Final Slurry Wall Design
Containment Barrier
Wall Installation

MIDCO I SITE

Project No. 03144-011

Re: Submittal for Road Crossing Design Change
Containment Barrier Wall (CBW) Installation
Midco I Site
7400 West Fifteenth Avenue
Gary, Indiana

VOLCLAY PANEL INSTALLATION DETAIL
SCALE: 1" = 1'

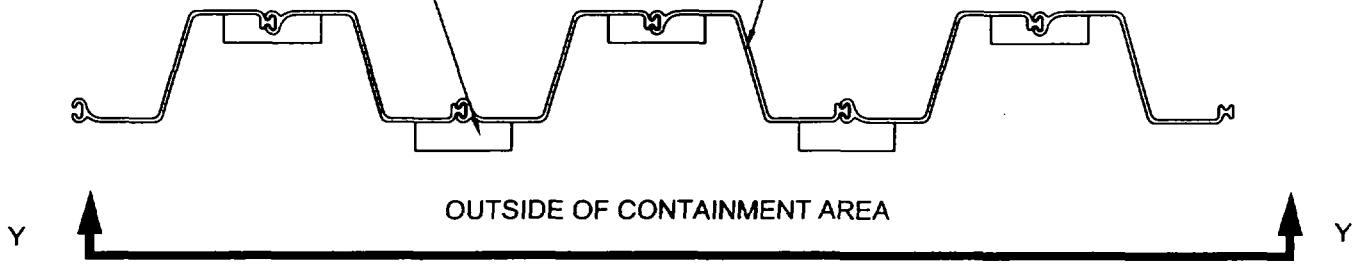
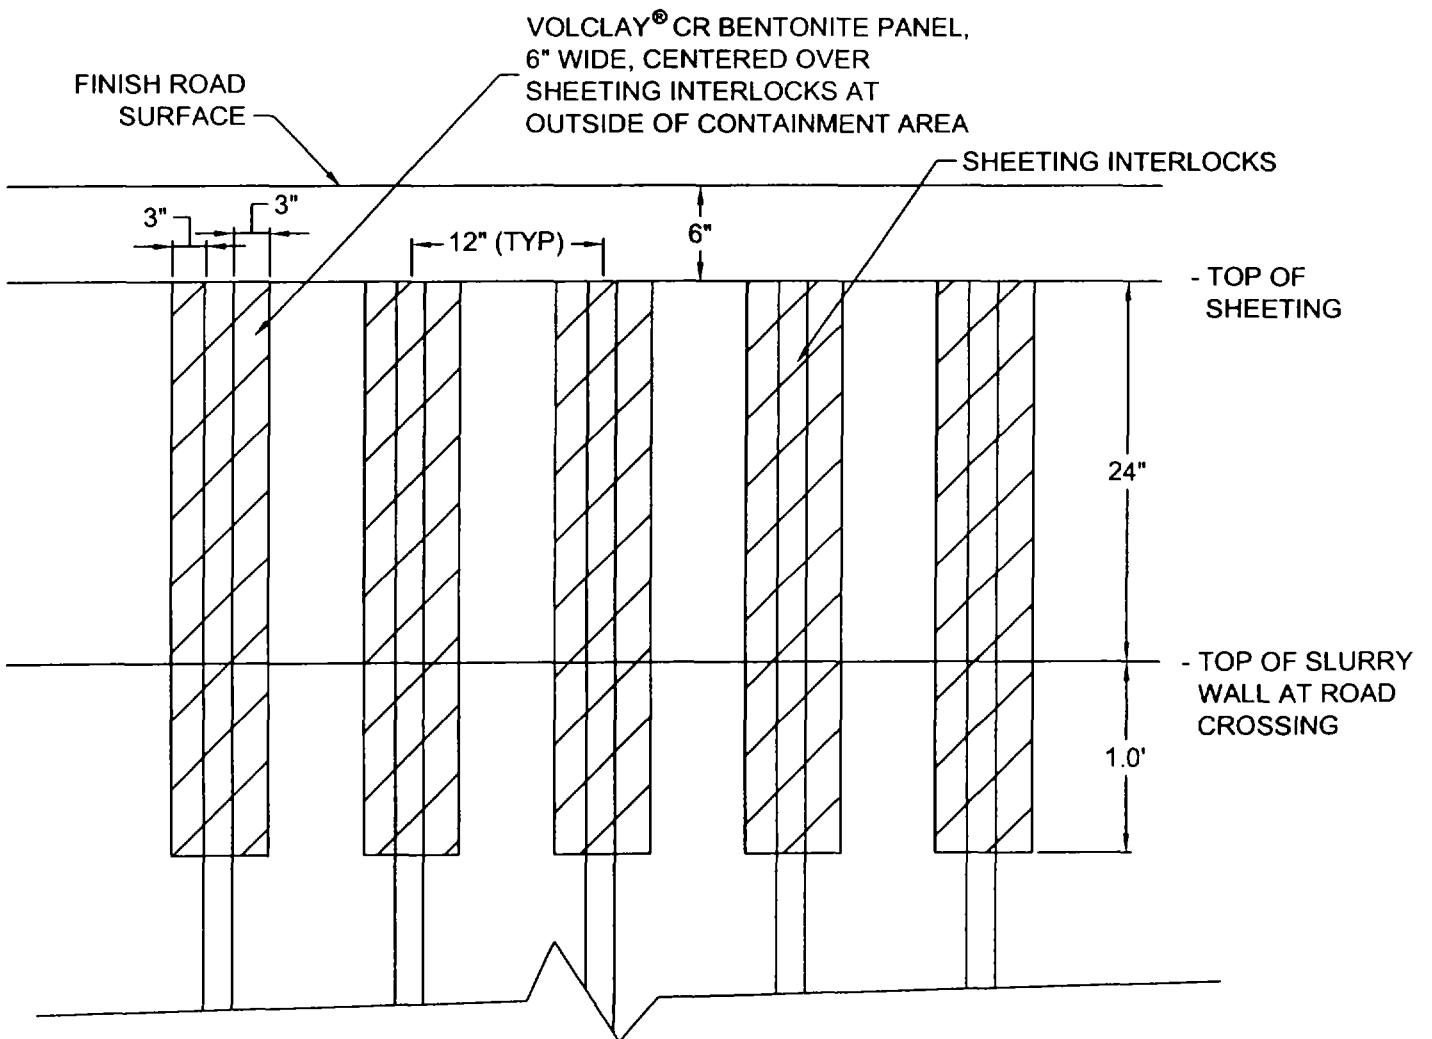
As a follow-up to our telephone conversations, we are enclosing details for a proposed design change at the road crossings. The change involves placing a bentonite Volclay[®] CR bentonite panel over the Shoreguard sheeting interlocks after the sheeting has been installed instead of solvent welding the sheeting before placing the sheets in the CBW. The Volclay[®] CR bentonite panels are to be installed on the sheeting side that faces to the outside of the CBW. The Volclay[®] CR bentonite panels have been specified since the bentonite used is designed to be used where contaminated groundwater or high levels of salt concentrations are in the water. By using the Volclay[®] CR bentonite panels at the interlocks seepage through the interlock locations would be small considering the minimal void space at the interlocks as well as the low permeability of the Volclay[®] CR bentonite panels. Technical information regarding the Volclay[®] CR bentonite panels is included with this letter.

PLACE VOLCLAY® CR
BENTONITE PANELS AT
EACH SHEETING
INTERLOCK ON OUTSIDE
OF CONTAINMENT AREA
